Economic Commission for Europe**Administrative Committee for the TIR Convention, 1975****Technical Implementation Body****Eighth session**

Geneva, 8 October 2024

eTIR conceptual, functional and technical specifications:**Version 4.4:****Concrete amendment proposals****Amendment proposals considered by TIB****Note by the secretariat****I. Background**

Figure I
Current customs management of guarantees class diagram

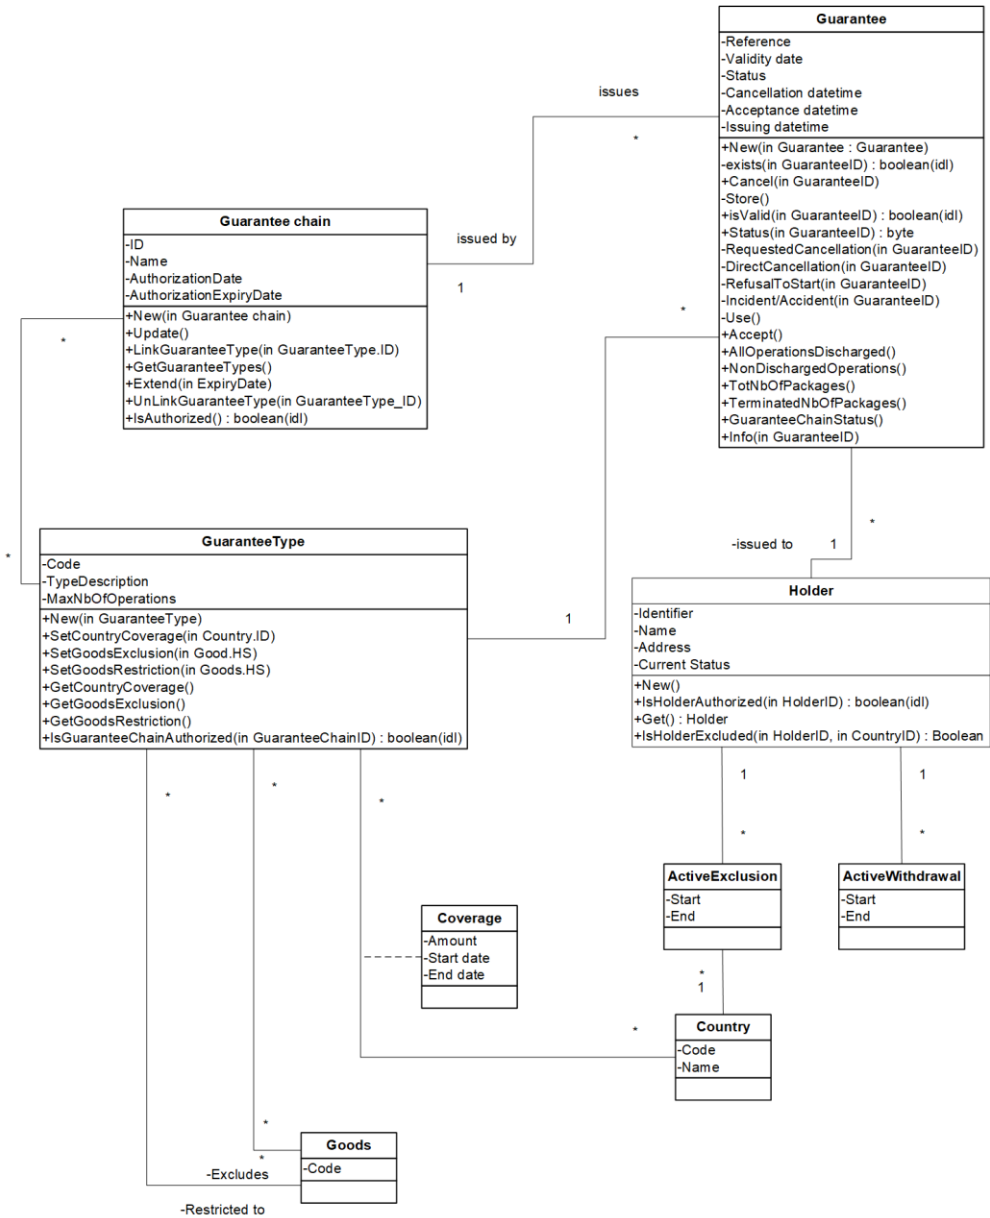
24. UML Class diagrams used in version 4.3 of the eTIR functional specifications contain not only classes, their relationships and their attributes, but also a set of methods that were aimed at facilitating the development of the eTIR international system. As such, these methods have little to no use for the countries that wish to amend their customs system to implement the eTIR procedure. Figures I and II below show the difference between the current and the simplified version of the customs management of guarantees class diagram (Figure 1.19 of the eTIR functional specifications).

25. At its third session, TIB agreed to simplify the class diagrams.

Figure III
UML activity diagram for the Start TIR operation process

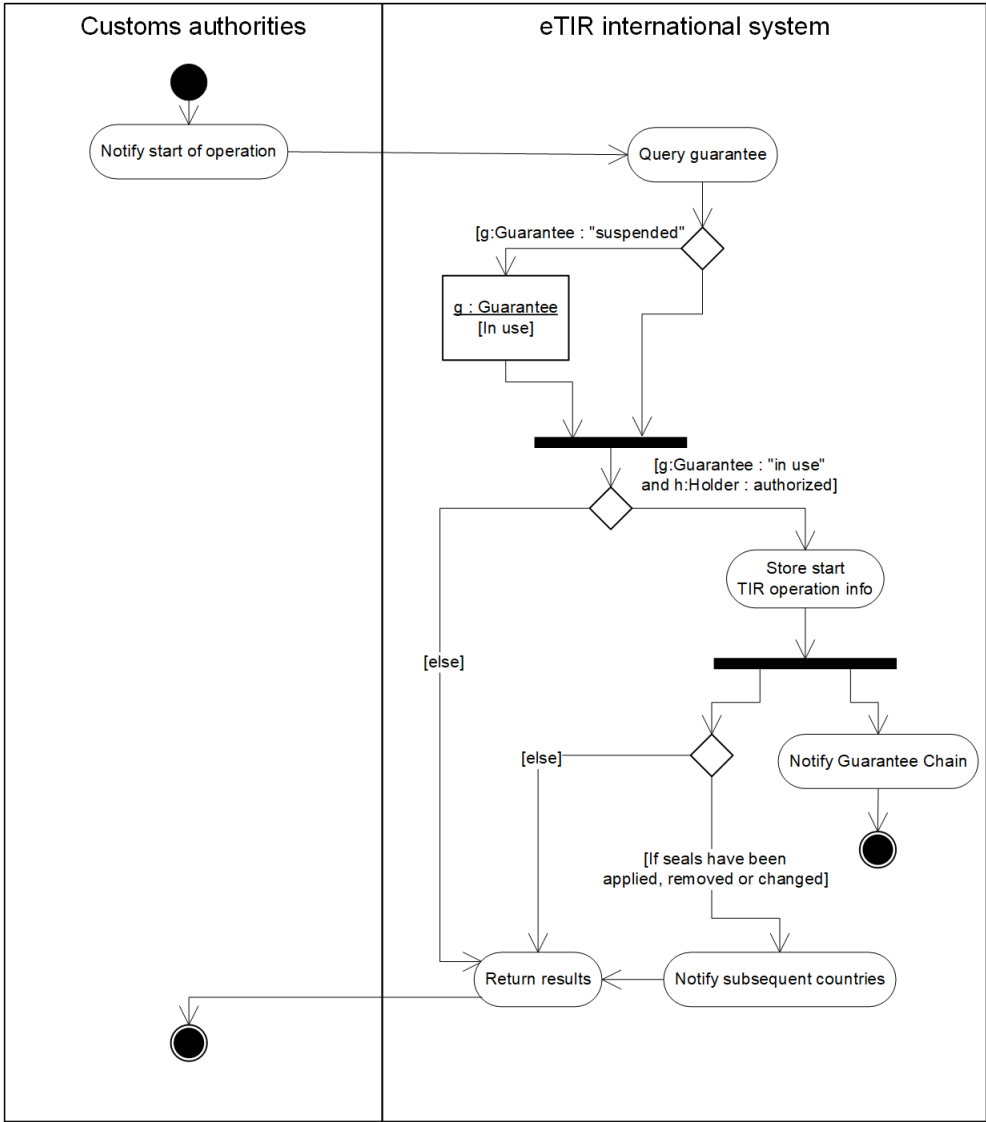
26. In version 4.3 of the eTIR specifications, in line with the Unified Modelling Methodology (UML) chosen originally for the eTIR project, the modelling of processes is done using UML activity and sequence diagrams. In recent years, the business process model and notation (BPMN) has gained in popularity in both the business and Information and Communication Technologies (ICT) communities and is, therefore, better understood by laymen and experts alike. With that in mind, TIB might wish to consider if, in version 4.4 of the eTIR specifications, BPMN should replace the activity and sequence diagrams used in version 4.3. Figures III, IV and V below show the UML activity diagram (Figure 12 of the eTIR concepts), UML sequence diagram (Figure 1.9 of the eTIR functional specifications) and the Business Process Diagram for the Start TIR operation process.

27. At its third session, TIB agreed to replace the existing diagrams (in Unified Modelling Methodology – UML) in the conceptual and functional specifications with the newly proposed diagrams (in Business Process Model and Notation – BPMN), in line with the examples above.
